Würth Elektronik eiSos GmbH & Co. KG EMC & Inductive Solutions

Product / Process Change Notification (PCN)		
<ul><li>☐ Major change</li><li>☑ Minor change</li></ul>		
PCN #:	PCN_FeSTARKEY_20220217	Change Category:
Affected Series:	WE-STAR-KEY; 74271	<ul><li>□ Equipment / Location</li><li>☑ General Data</li><li>□ Material</li></ul>
PCN Date:	November 17, 2021	□ Process
Effective Date:	February 17, 2022	<ul> <li>□ Product Design</li> <li>□ Shipping / Packaging</li> <li>□ Supplier</li> <li>□ Software</li> </ul>
Contact:	Product Management	Data Sheet Change:
Phone:	+49 (0) 7942 - 945 5001	
Fax:	+49 (0) 7942 - 945 5179	Attachment:
E-Mail:	pcn.eisos@we-online.com	□ Yes ⊠ No
DESCRIPTION AND PURPOSE OF CHANGE:		
As a datasheet information correction and improvement, Würth Elektronik will correct the tolerances for the STAR-KEY and remove technical not relevant dimensions.		
This is a datasheet correction only. There will be no change in form, fit, function, quality or reliability of the product.

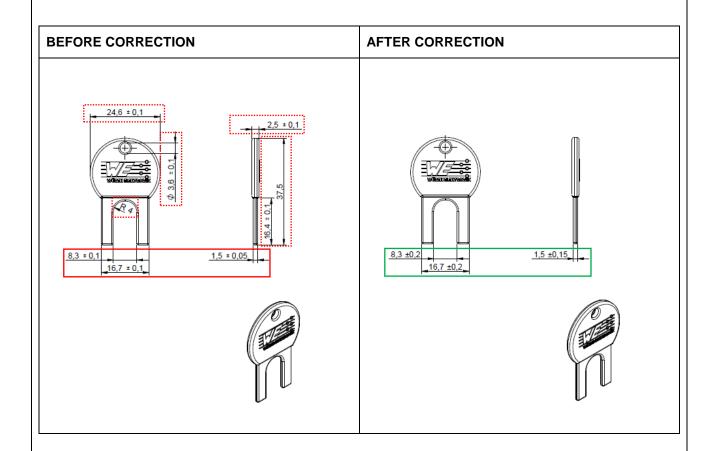
This change will have no influence to the current functionality of the STAR-KEY. There is no change of the product. It is only a correction of datasheet.

Removal of technical not relevant dimensions

Correction of Tolerance
